**RE: PETITION NO. 1690** - The Connecticut Light and Power Company d/b/a Eversource Energy petition for a declaratory ruling, pursuant to Connecticut General Statutes §4-176 and §16-50k, for the proposed Haddam Substation to East Haddam Junction Rebuild Project consisting of the replacement and reconductoring of electric transmission line structures along approximately 1.5 miles of its existing 115-kilovolt (kV) 1772 Line and 345-kV 348 Line shared right-of-way and associated Connecticut River crossing between Haddam Substation in Haddam and East Haddam Junction in East Haddam, Connecticut, and related electric transmission line and substation improvements.

**Response to Council Interrogatory No. 41 to Petitioner**

CT SITING COUNCIL PETITION NO. 1690  
RESPONSE TO INTERROGATORY 41  
HADDAM SUBSTATION TO EAST HADDAM JUNCTION:  
1772 AND 348 LINES REBUILD PROJECT  
EAST HADDAM & HADDAM, CT

**CRGC EXHIBIT D - East Haddam CT River**

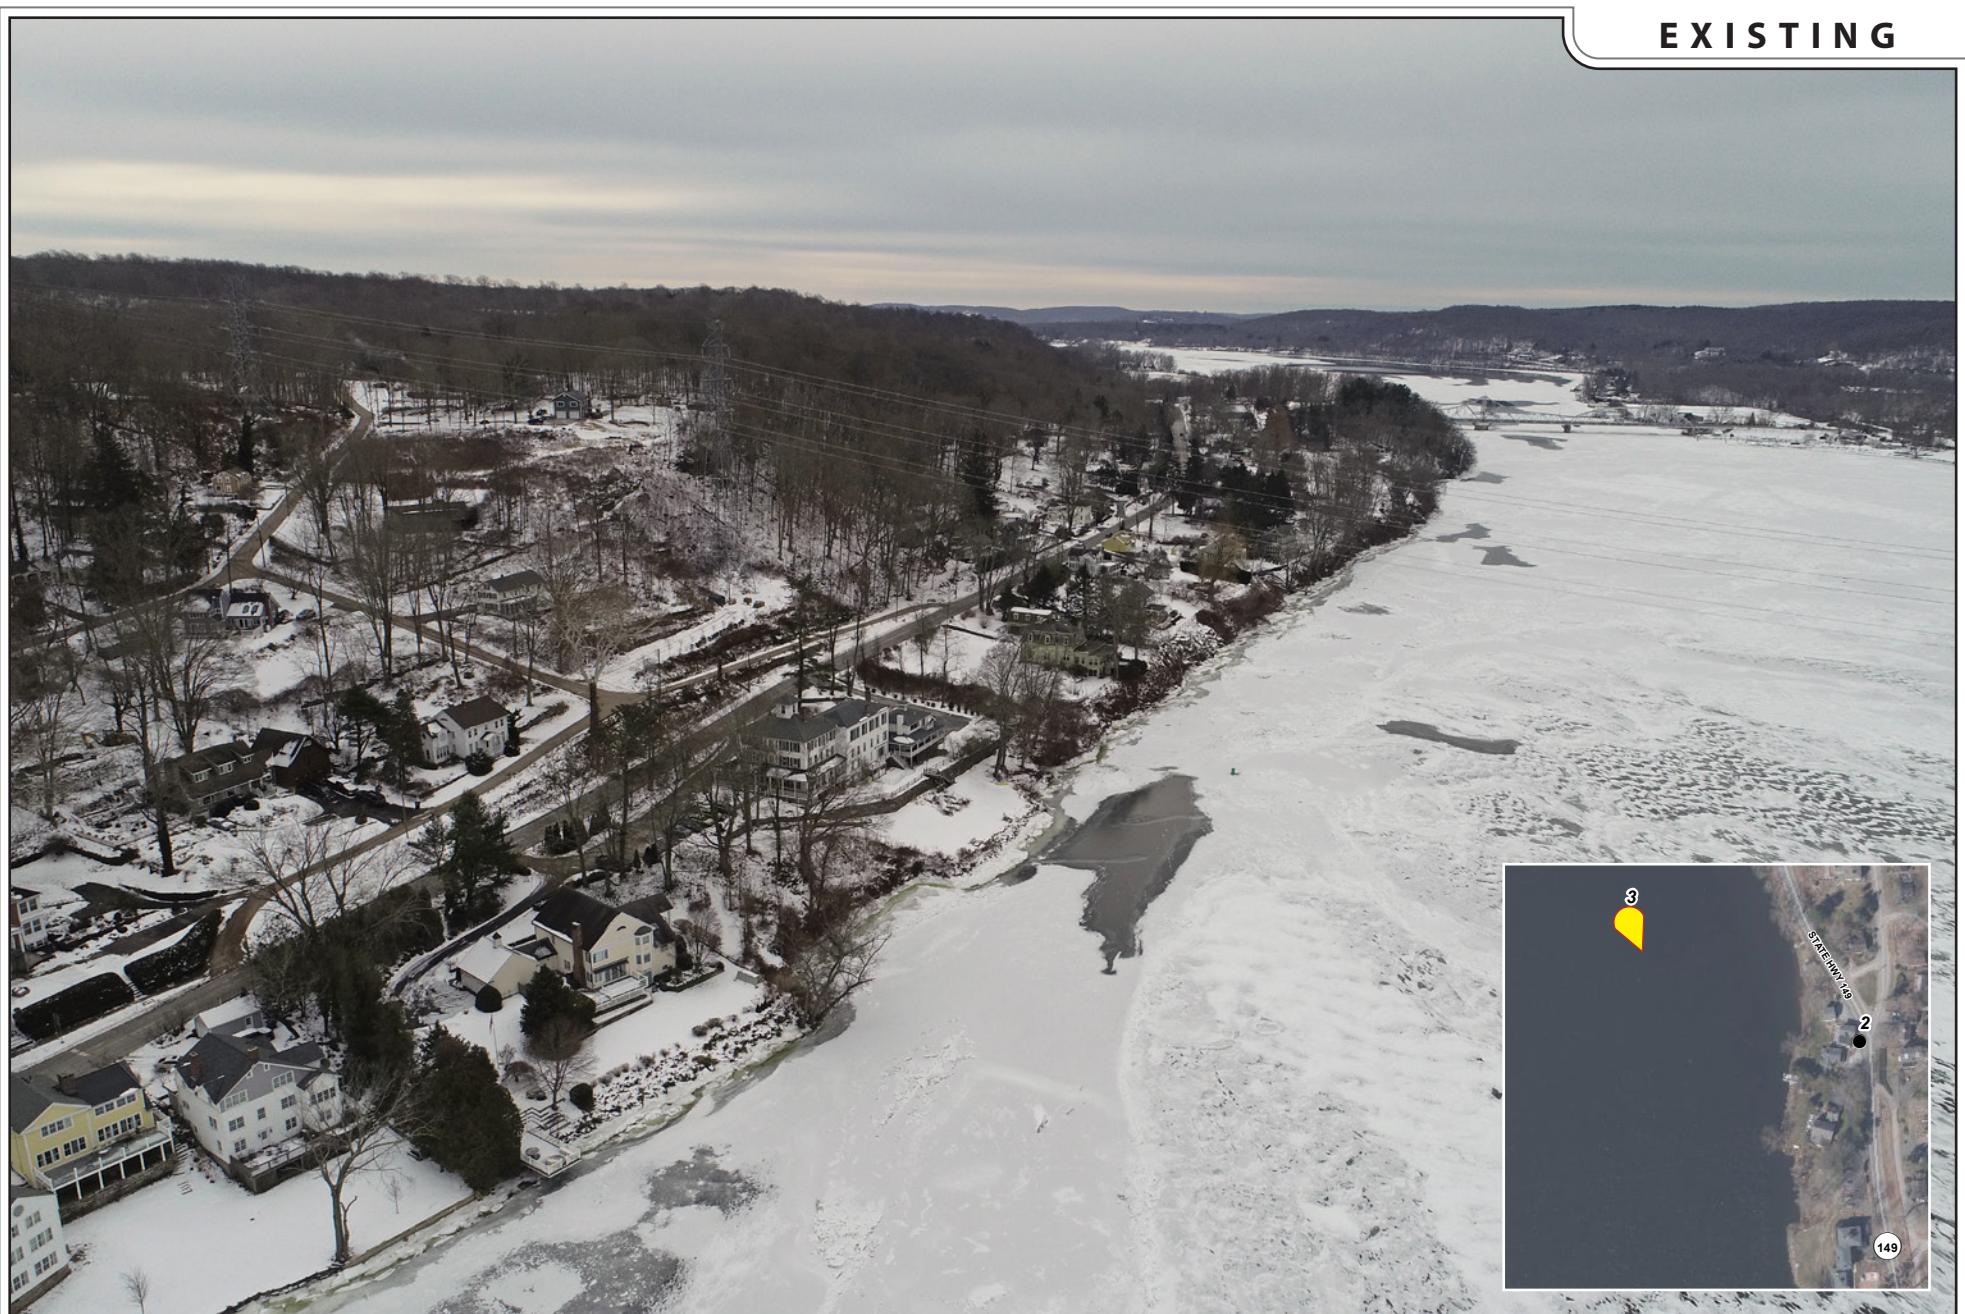
Question: Referencing the December 3, 2025 CRGC comments under Visual Impacts, please provide comparable photo simulations from the locations identified in CRGC Exhibits A-D – Representative uncropped photographs of existing conditions - that are representative of the proposed Project, Alternative 1 and Alternative 2.

- **CRCG Exhibit D** is an aerial photograph taken above the Connecticut River, looking southeast, with a view of the transmission lines across the eastern portion of the river and of existing double-circuit lattice Structures 9813 and 9812 in East Haddam. Eversource reproduced this view using a drone overflight. As noted above, the Project will remove existing Structure 9813; the two single-circuit monopole replacement structures (Structures 9813 and 3488), which will be located farther to the east along the ROW, are visible in the photo-simulations for the proposed Project and the two alternative overhead line designs for CRGC Exhibit D. For the Project, existing double-circuit lattice Structure 9812 will be removed and not replaced. The removal of this structure is reflected in the photo-simulations for CRGC Exhibit D.

CRGC Exhibit D is an aerial photograph. While photo simulations can, in general, be generated from aerial imagery, it is not possible to prepare an accurate simulation from Exhibit D because the image lacks the specific camera location, altitude, orientation, and lens parameters required to establish the viewing geometry necessary for a reliable simulation.

**VIEW TO SOUTHEAST ABOVE CONNECTICUT RIVER SHOWING MAIN STREET HADDAM AND EXISTING STRUCTURES 9813 AND 9812**
